Summary for DRH19-00252

Planning Division Project Report

File Number	DRH19-00252
Applicant	Mitchell Korte / CDG Acquisitions, LLC
Property Address	270 E. Myrtle Street
Public Hearing Date	July 10, 2019
Heard by	Design Review Committee
Design Review Supervisor	Josh Wilson

FIRST FLOOR PLAN (PODIUM)

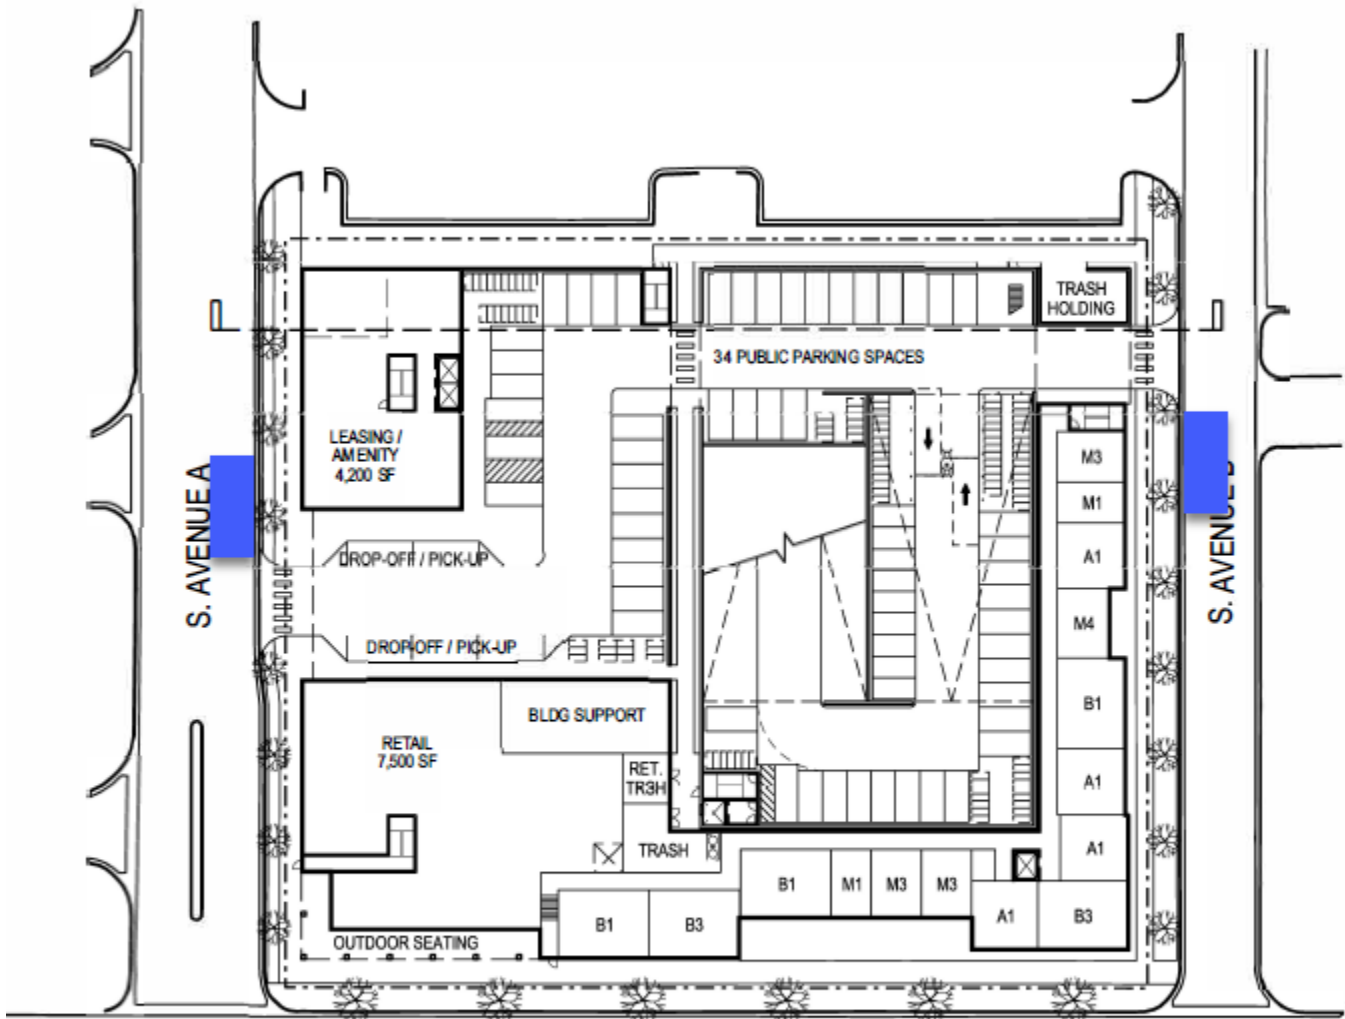
On May 10, the Accessible Parking Committee recommended two future on-street accessible parking spaces be implemented as shown in the graphic below (i.e. southernmost parking stall where parking is allowed on Ave A as well as the stall immediately south of the proposed driveway on Ave B adjacent to 270 E Myrtle). Parking is currently restricted in both areas, but we anticipate that on-street parking could be allowed with ACHD approval. The Committee requested that the stalls be designed to meet PROWAG standards (attached) if the conditions identified in PROWAG R309 are met and if on-street parking is allowed and regulated in the future.

Realizing that this type of design information is typically not provided for re-zone applications, the Committee agreed that this information would be beneficial for the developer to have as they prepare a site design (and assuming Parking Services and Current Planning agree with the recommendation).

SITE PLAN

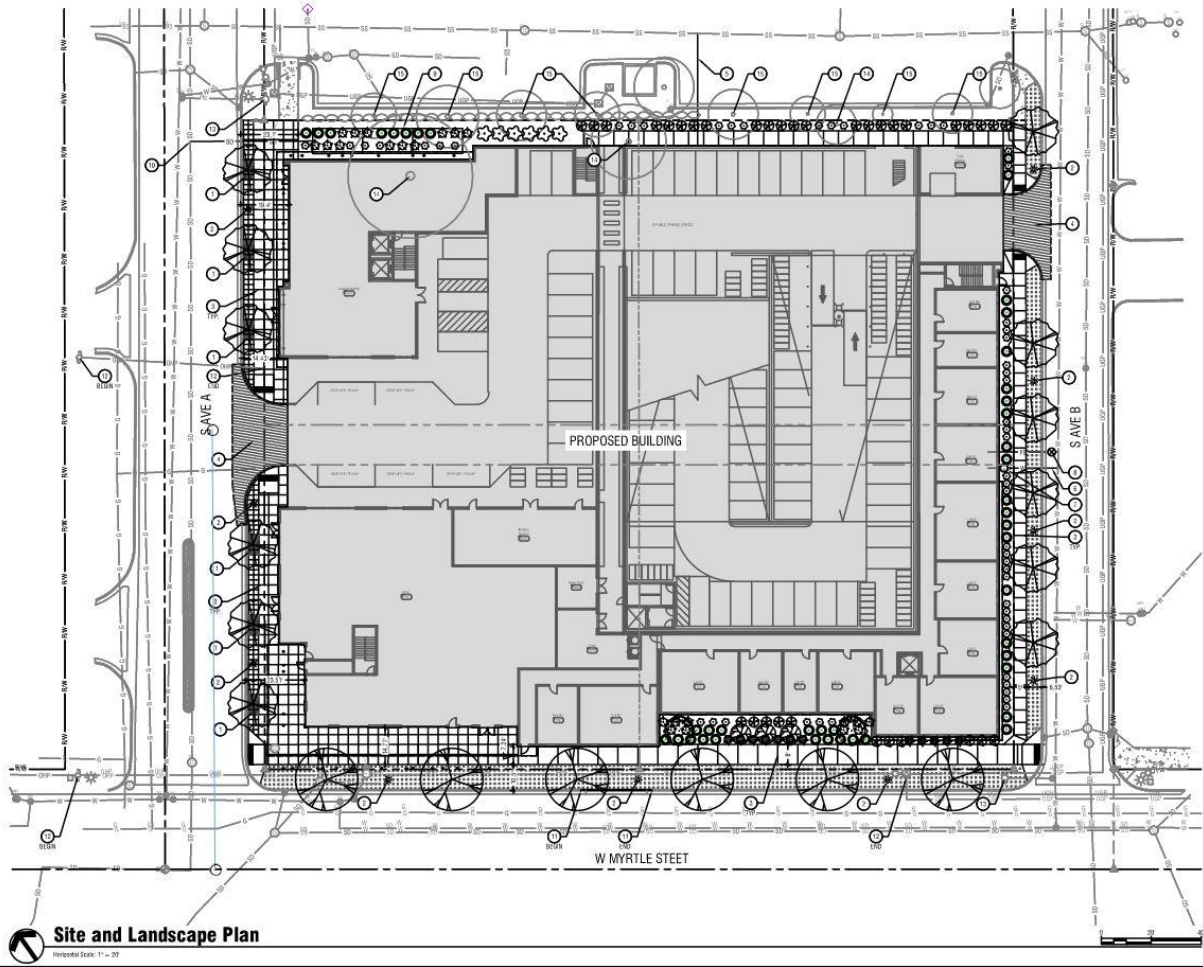
4. Install “No Parking” signs on Avenue A abutting the site.
5. Construct a curb return type driveway onto Avenue B located near the north property line.
6. Repair or replace any damaged or deficient improvements along Avenue A and Avenue B abutting the site.
7. A Traffic Impact Fee will be assessed by ACHD and will be due prior to issuance of a building permit. Please contact the ACHD Planner (see below) for information regarding impact fees.
8. Submit civil plans to ACHD Development Services for review and approval. The impact fee assessment will not be released until the civil plans are approved by ACHD.
9. Comply with the Standard Conditions of Approval as noted below.
